# ADDENDUM No. 1

RFP No. 22-50

## Russell Street Improvements

**UNDERGROUND STORMWATER STORAGE CONTROL STRUCTURE**

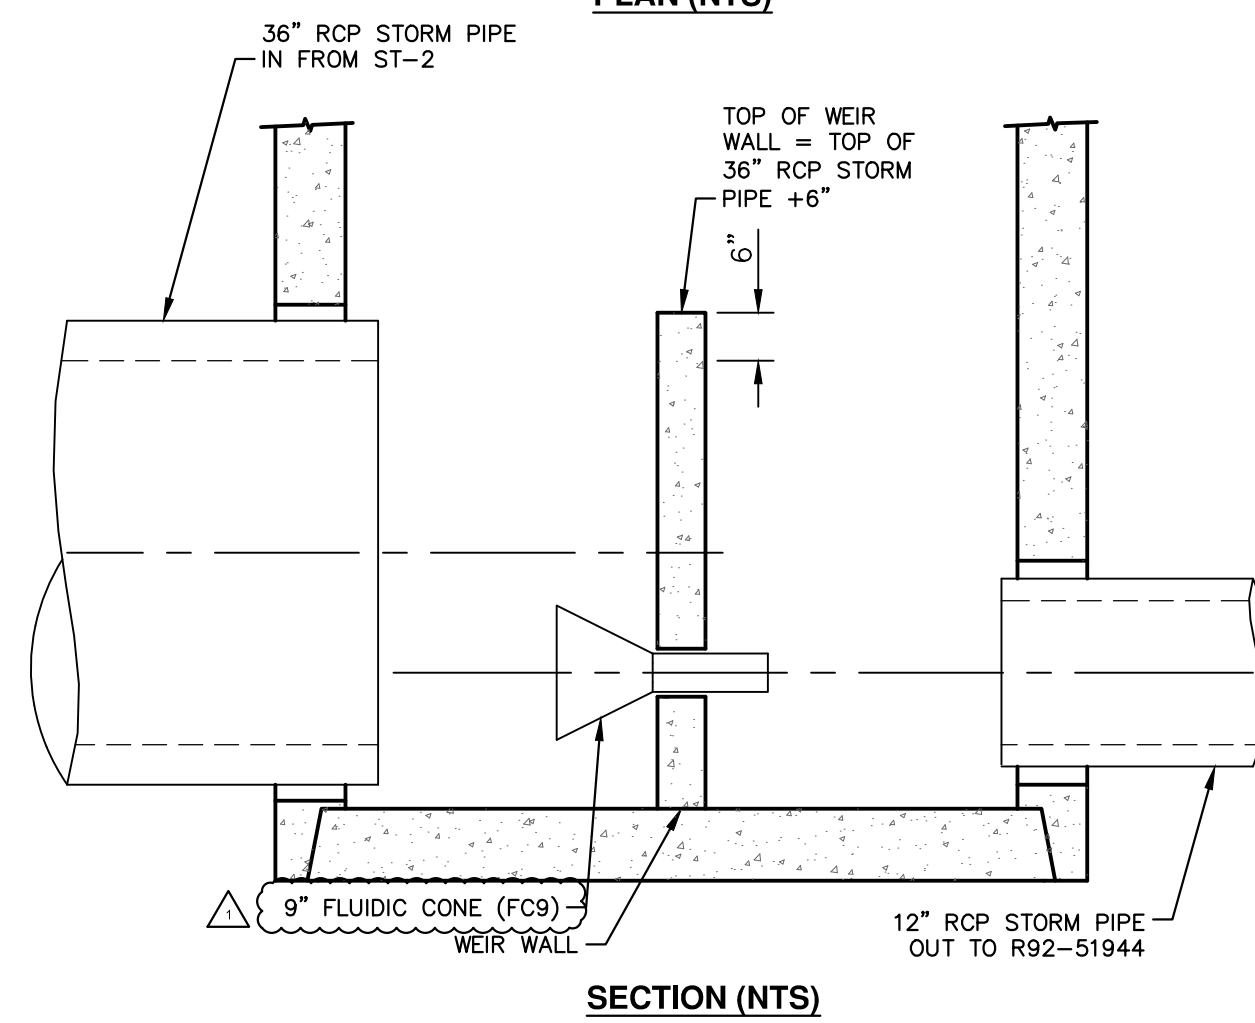
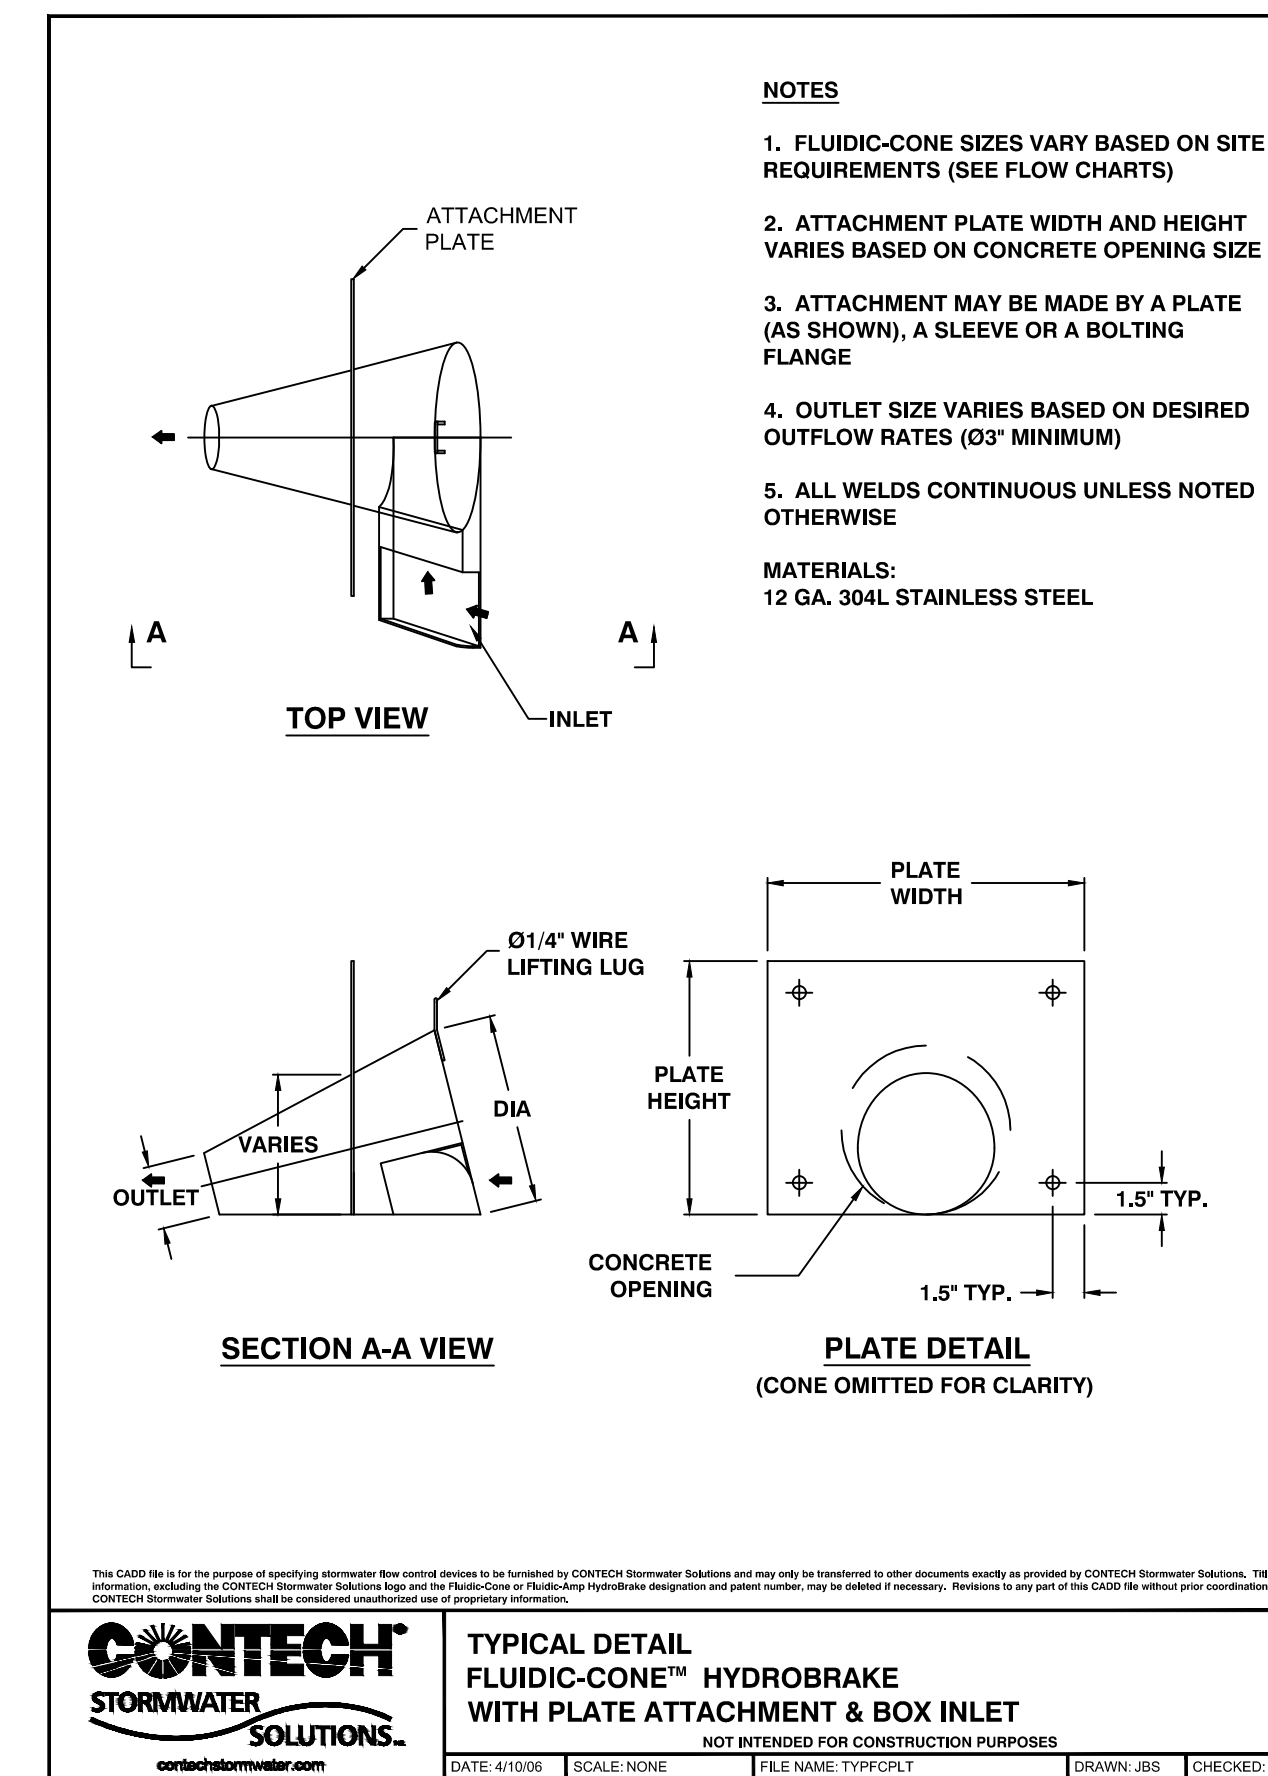
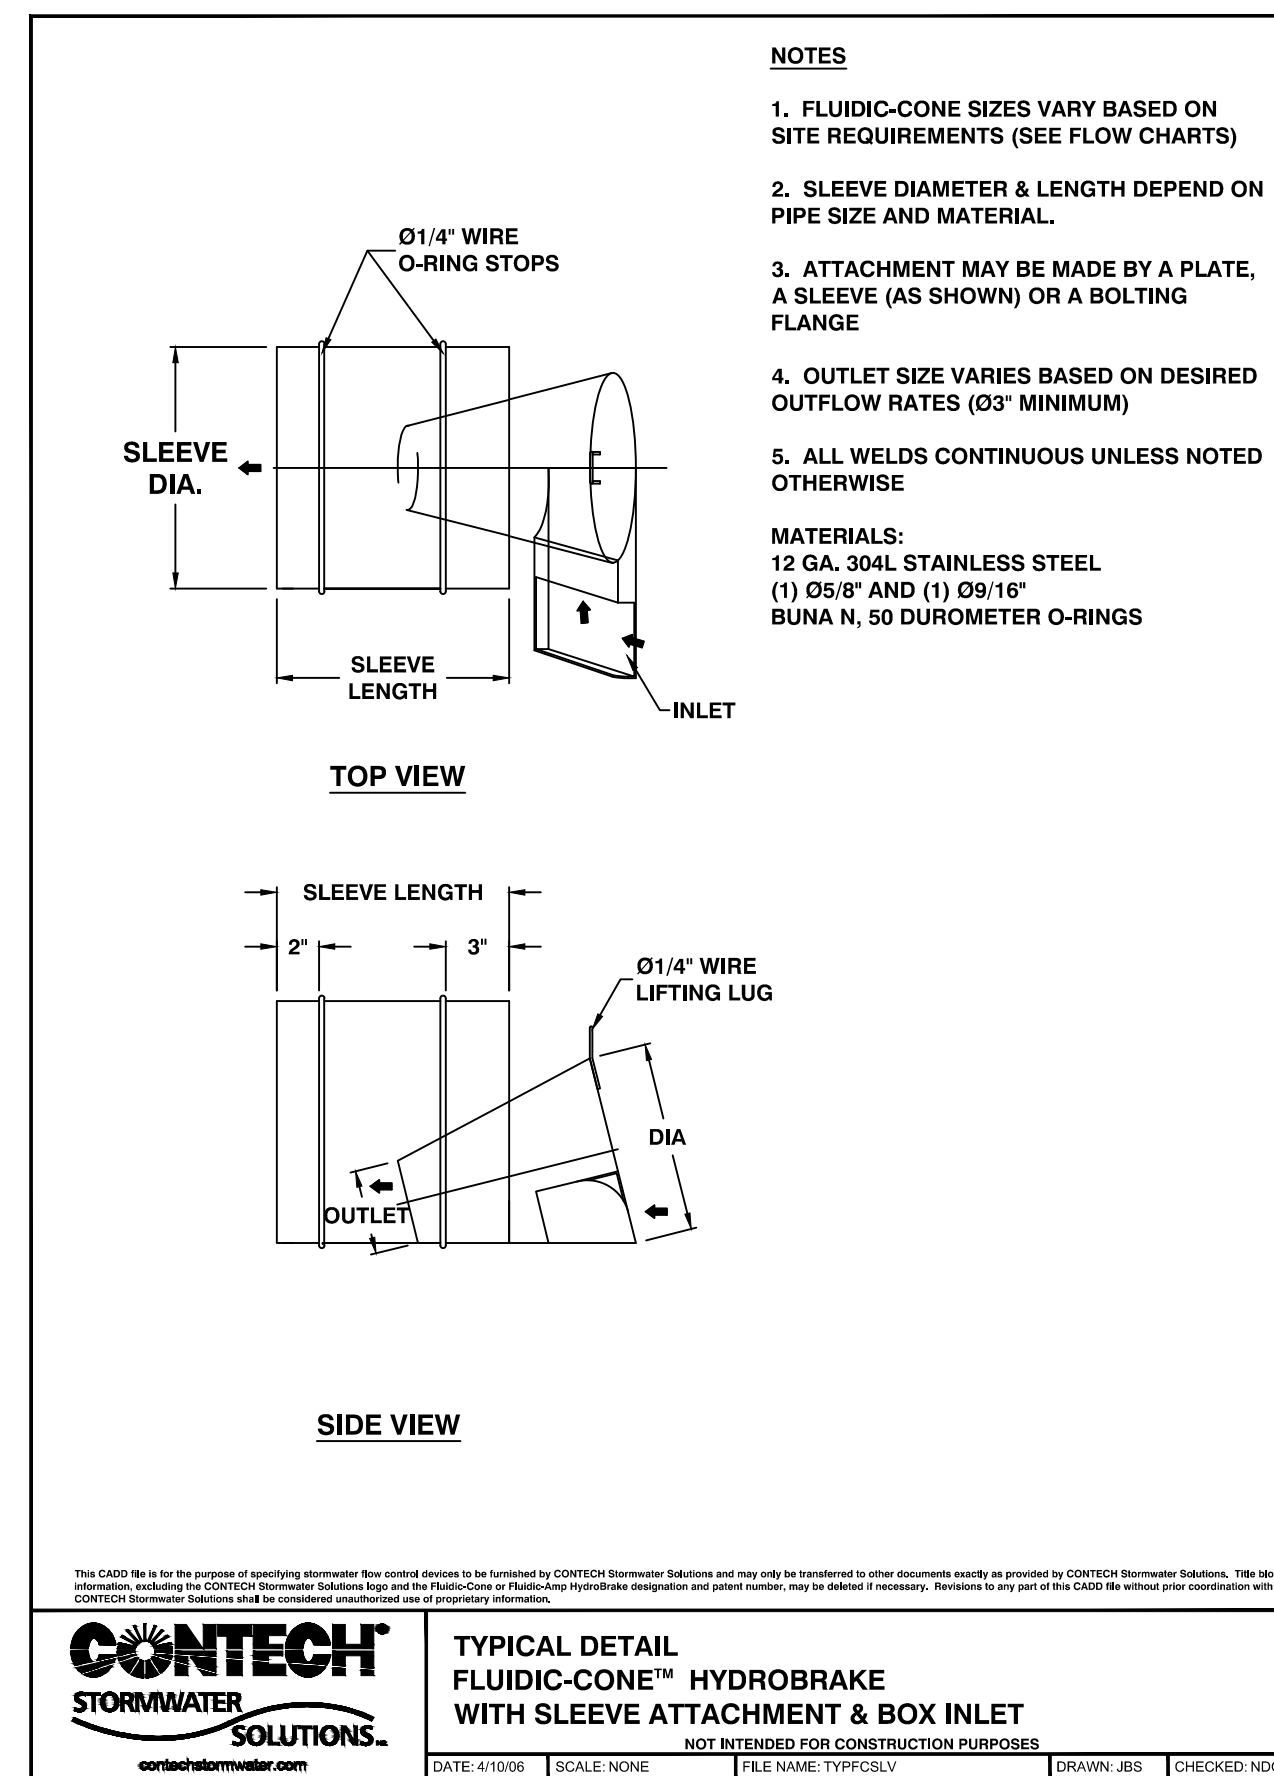
Section/Page(s)	Change
Pages 2-4	The Bid Form has been amended to reflect the modifications of this Addendum No. 1. Item number 254, Handrail, Lump Sum has been added.
Pages 5-6 + Plans	The project is adding handrail to the north side ramps to Maple Meadows as shown in the attached drawings (Plan Sheet 8A, Plan Sheet 11), detailed specification dated 06-02-2022, and Bid Form.
Plans Only	The controlled stormwater outlet structure detail has been corrected to show the proper Fluidic Cone outlet size of 9-inches (Plan Sheet 19, dated 06-02-2022). The Fluidic Cone model remains the same (FC-9).

INCLUDED IN PAY ITEM FOR STORM CONTROL STRUCTURE 1. THE ABOVE DETAILS ARE EXAMPLES OF THE FLOW RESTRICTION DEVICES REQUESTED FOR THE PROJECT. OTHER SIMILAR DEVICES WILL BE CONSIDERED FOR USE. FLOW RESTRICTION DEVICES MUST CONFORM TO THE DETAILED SPECIFICATION.
